***Docket Item #5***  
***Text Amendment #2017-0001***  
***Floor Area Ratio***

<b>Issue:</b> (A) initiation of a Text Amendment, and (B) Public hearing and consideration of a Text Amendment to the Zoning Ordinance to amend sections 2-145, 2-195, and 7-202 and to add new sections 2-113.1 and 2-194.1 regarding floor area ratio.	Planning Commission Hearing:	February 6, 2018
	City Council Hearing:	February 24, 2018
<b>Staff:</b> Mary Christesen, Zoning Manager <a href="mailto:mary.christesen@alexandriava.gov">mary.christesen@alexandriava.gov</a> Chrishaun Smith, Urban Planner <a href="mailto:shaun.smith@alexandriava.gov">shaun.smith@alexandriava.gov</a> Sam Shelby, Urban Planner <a href="mailto:sam.shelby@alexandriava.gov">sam.shelby@alexandriava.gov</a>

# ILLUSTRATION B

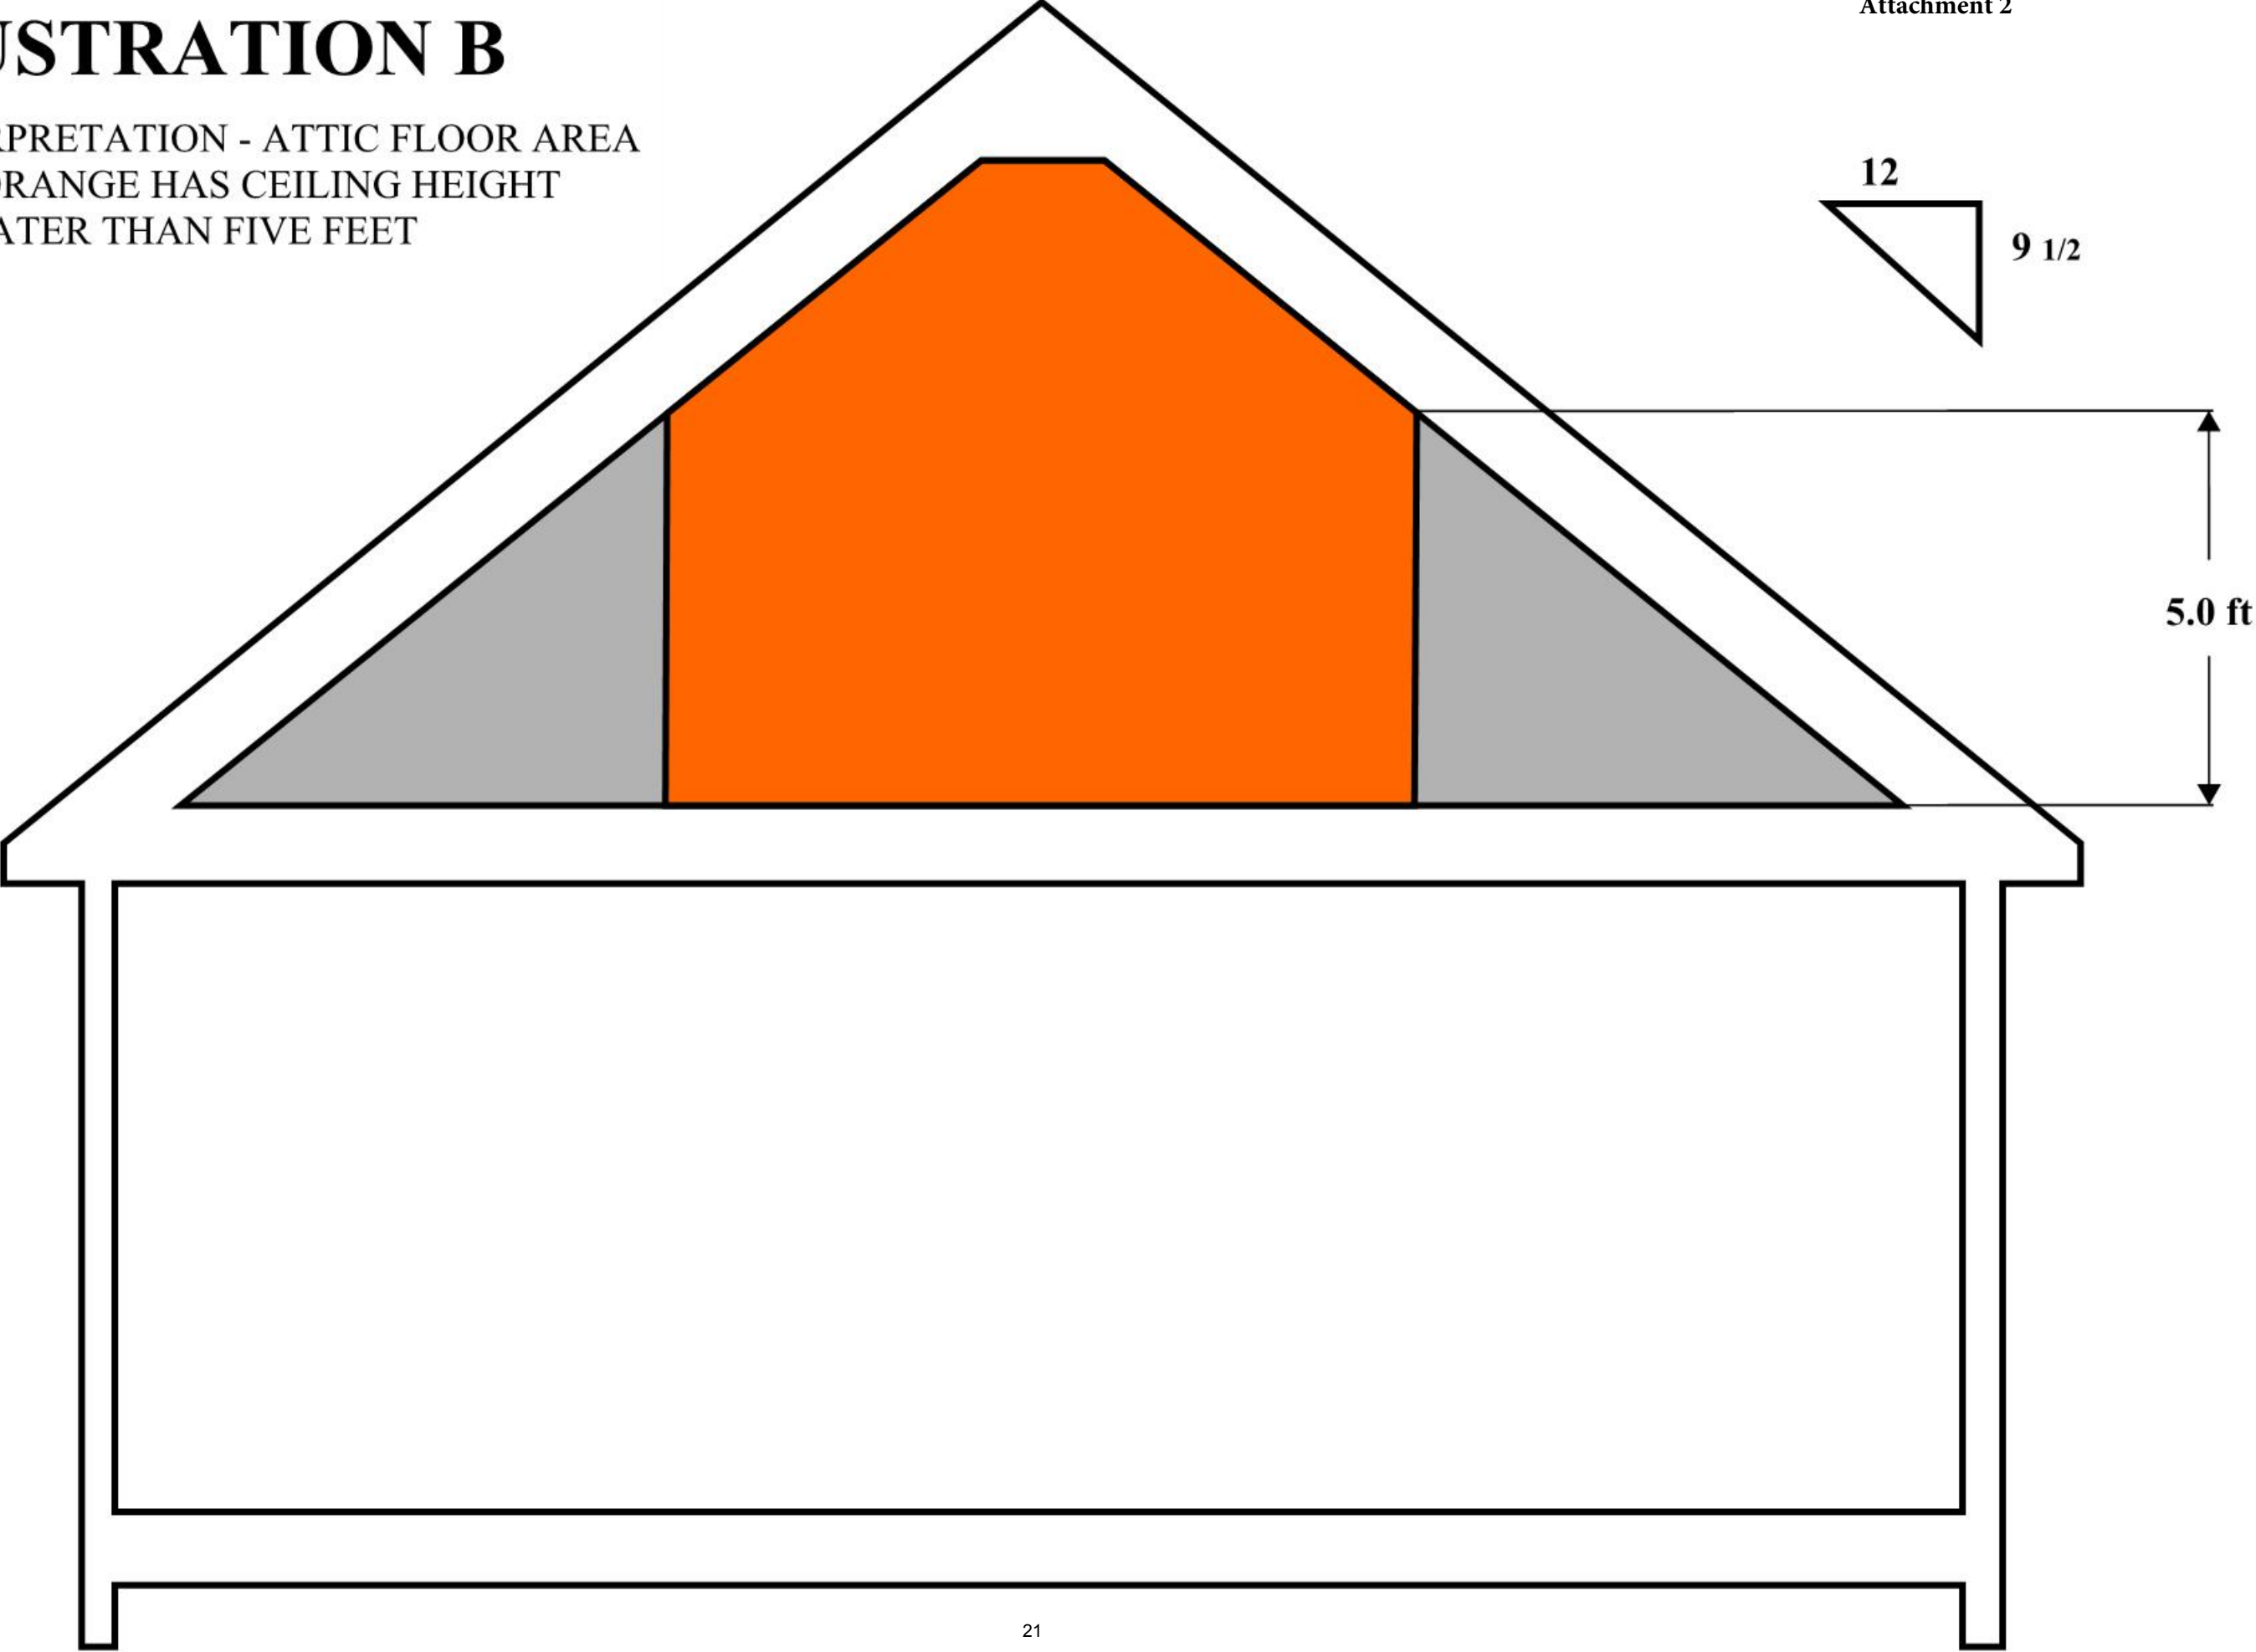
Illustrations A and B in attachment #2 of this report show staff's current interpretation of section 2-145(A)(4). These illustrations both show the same dwelling with a typical width of 24 feet and a 9½:12 roof pitch. Illustration A shows an attic with a collar tie which would be considered a "truss member supporting the outer roof structure." The collar tie reduces the attic's ceiling height to less than five feet and is fully excluded from floor area. Illustration B shows attic space that cannot be fully excluded from floor area because it has a ceiling height of more than five feet. The space that cannot be excluded from floor area is shown in orange.

CURRENT INTERPRETATION - ATTIC FLOOR AREA  
SHOWN IN ORANGE HAS CEILING HEIGHT  
GREATER THAN FIVE FEET
